AN ORDINANCE approving Change
Order No. 14 in connection
with Division I - Wastewater Plant.

PROJECT Water Quality Control Project OWNER City of Fort Wayne, IndianaDIVISION/~~XXXXXX~~ I - Water Pollution Control Plant AdditionsCHANGE ORDER NO. 14TO: Hagerman-Shambaugh - Joint Bidders% Hagerman Construction CorporationP.O. Box 690 - 403 Strauss BuildingFort Wayne, Indiana 46801

CHANGE ORDER NO. 14

PROJECT Division I - Water Pollution Control Plant Additions

FIGURE A
 WASTEWATER TREATMENT PLANT
 CITY OF FORT WAY, INDIANA

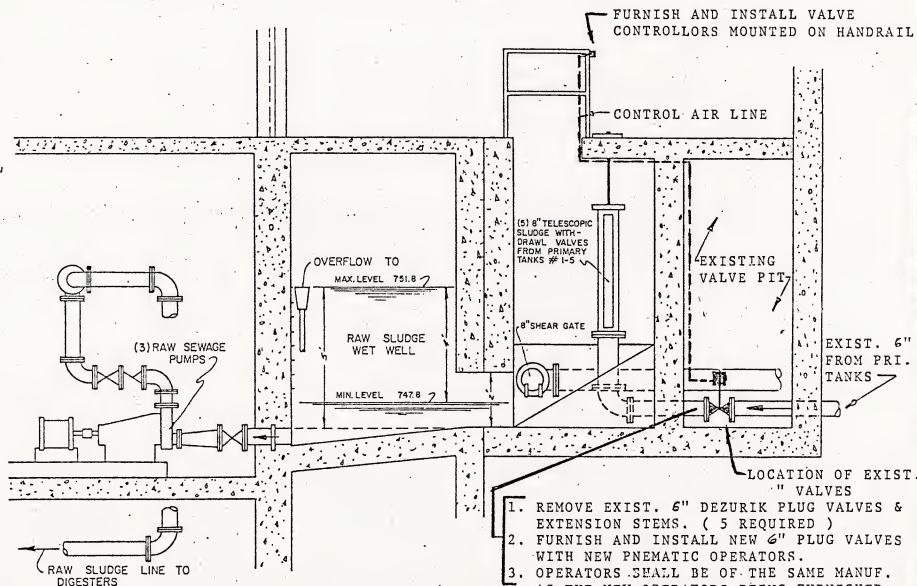
Furnish all labor and material necessary to remove 5 existing 6" manually operated primary sludge plug valves and replace with 5 new pneumatic operated plug valves as shown on attached Figure "A".

1. Necessity for change: The replacement of the five existing 6" plug valves is
proposed so that the same control and operation technique can be used on all
primary sludge drawing lines.

The control of all valves will be located in the same location and the accuracy
of valve control will be improved.

1. REMOVE EXIST. 6" DEZURIK PLUG VALVES & EXTENSION STEMS. (5 REQUIRED)
2. FURNISH AND INSTALL NEW 6" PLUG VALVES WITH NEW PNEUMATIC OPERATORS.
3. OPERATORS SHALL BE OF THE SAME MANUF. AS THE NEW OPERATORS BEING FURNISHED AS SHOWN ON SHEET NO. RS-1.
